Amdt to OL/Change to Tech Specs: Consisting of revisions with regard to drywell-torus differential pressure control implementing procedures, differential pressure control system instrumentation and torus water level instrumentation as requested in our 9-30-76 ltr....(40 cys encl rec'd)

PLANT NAME: Duane Arnold

November 3, 1976
IE-76-1694

PROPOSED CHANGE RTS-75 TO DAEC TECHNICAL SPECIFICATIONS

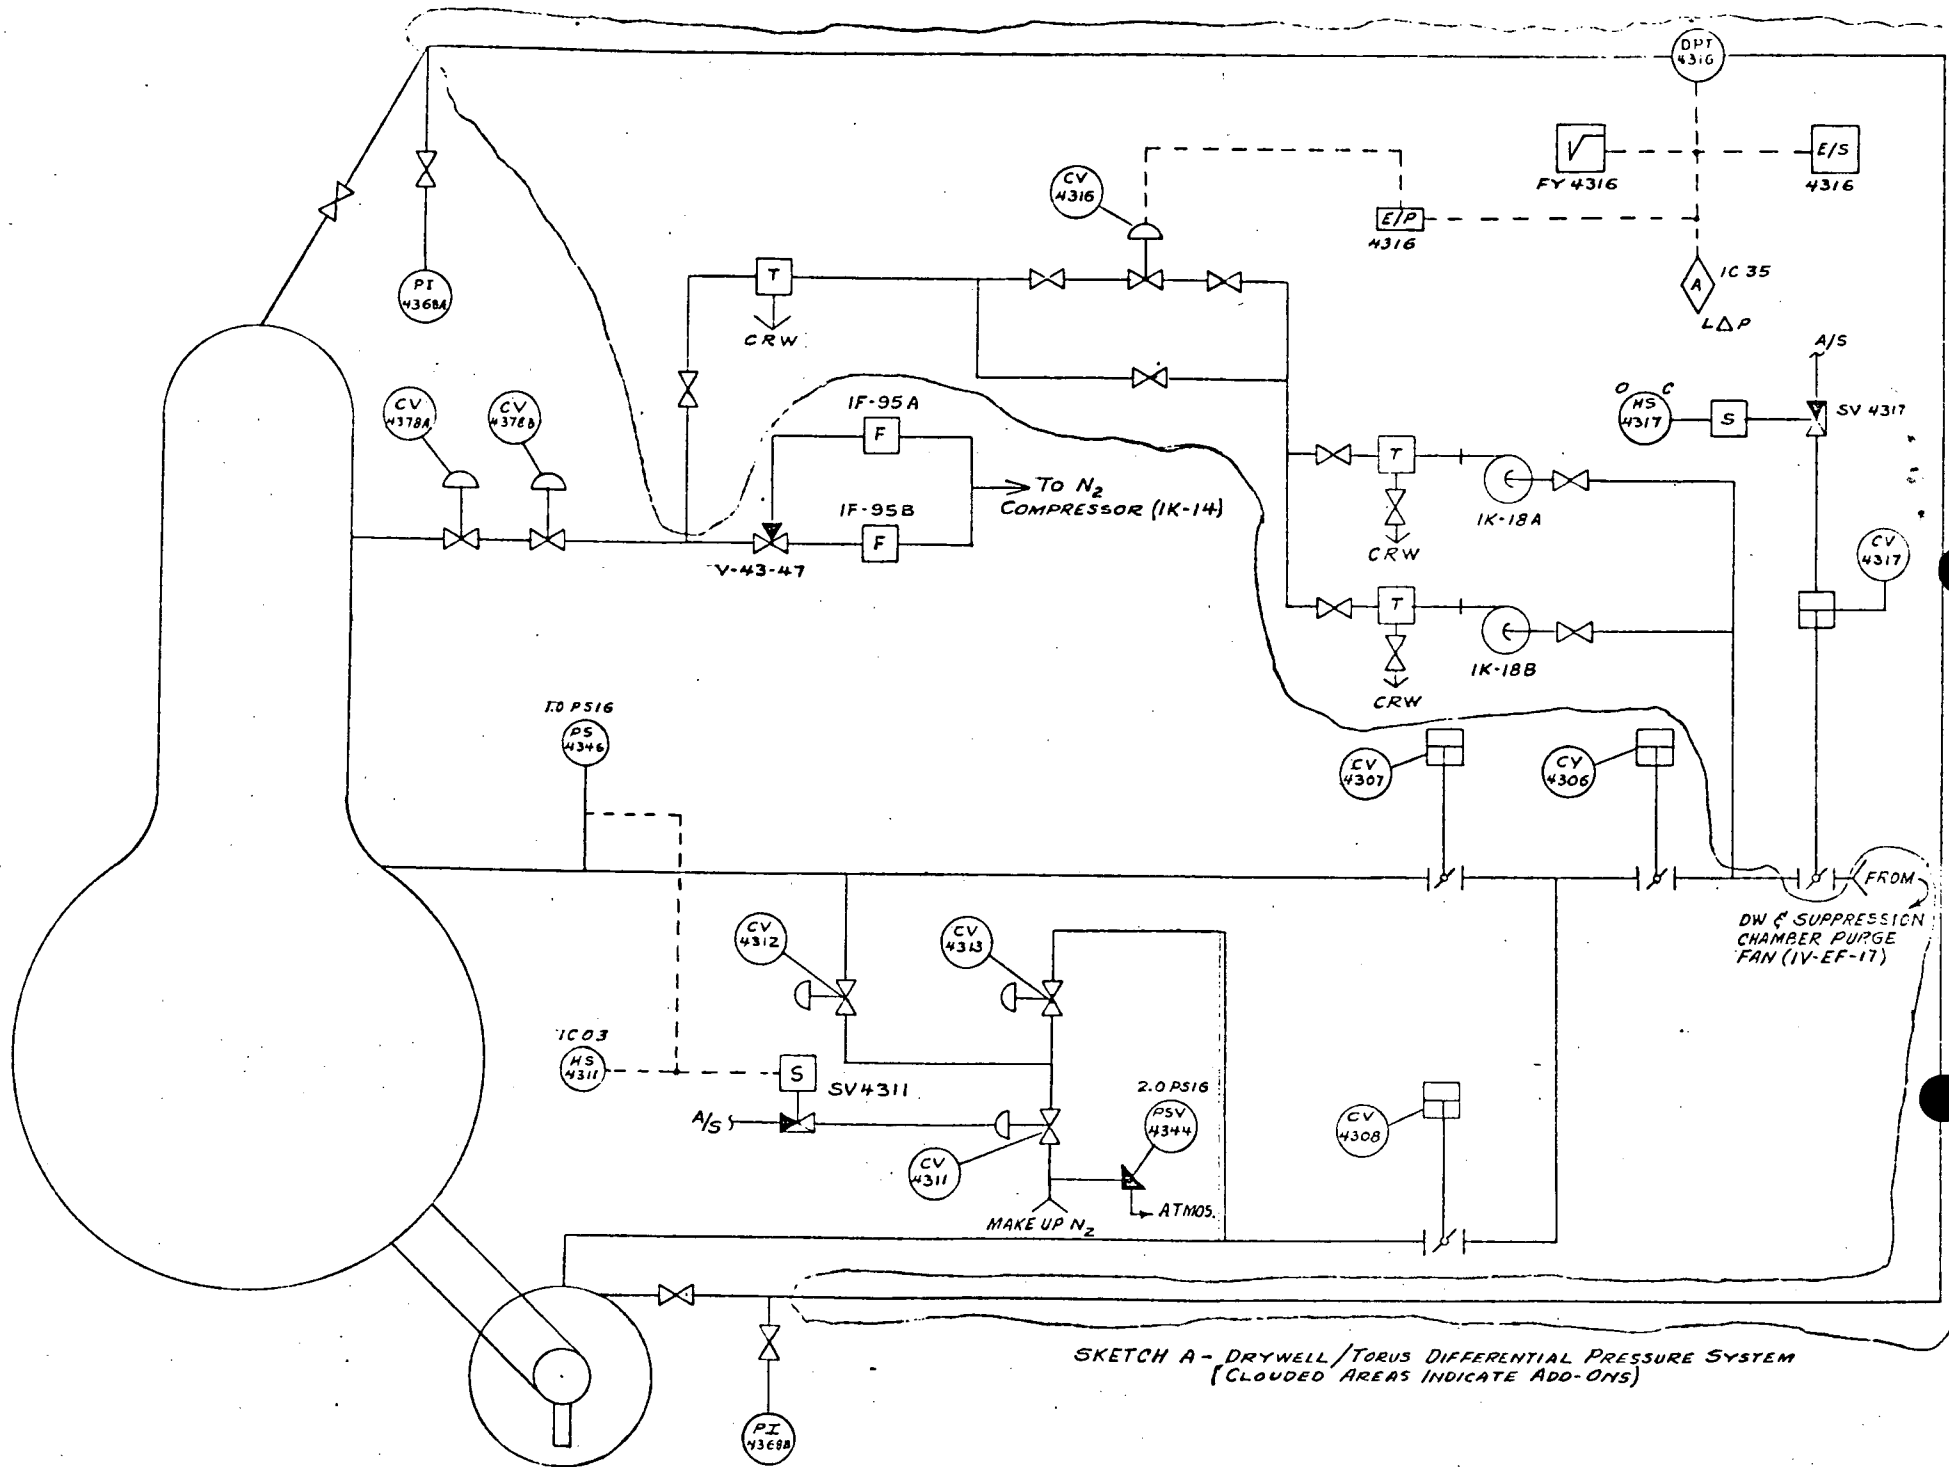
The instrumentation utilized to control the drywell/torus differential pressure is shown on Sketch A. The two functions provided by the instrumentation are control of CV4316 and the alarm. There is a single channel provided for the instrumentation functions. The alarm location is panel 1C35 in the control room.

Sketch B - Torus Level
Instrumentation

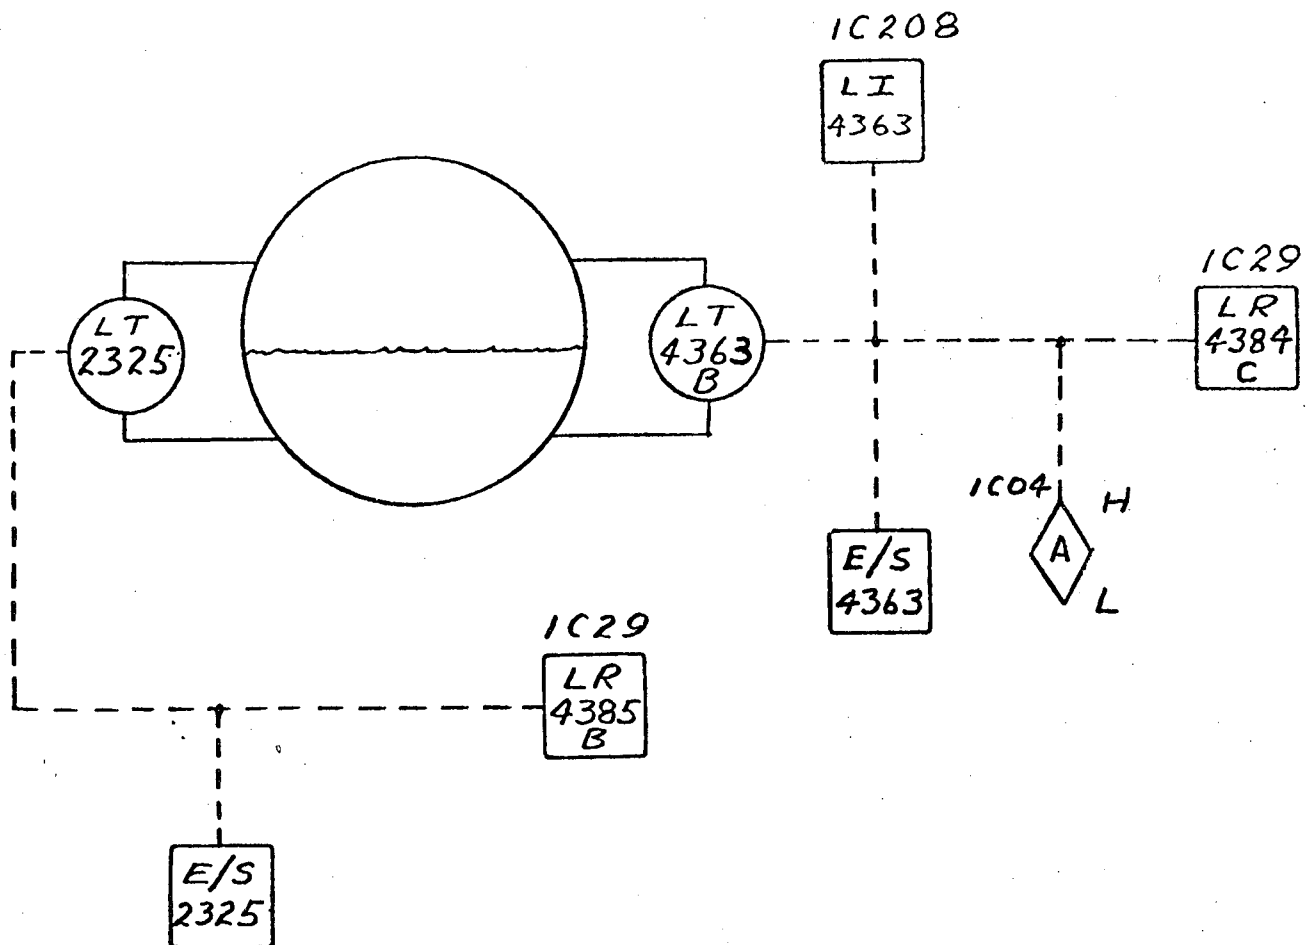
Two channels of level instrumentation as shown in Sketch B are provided. This provides a two channel level readout in the Control Room and a single channel high-low alarm in the Control Room. Ranges and accuracy of the instruments are:
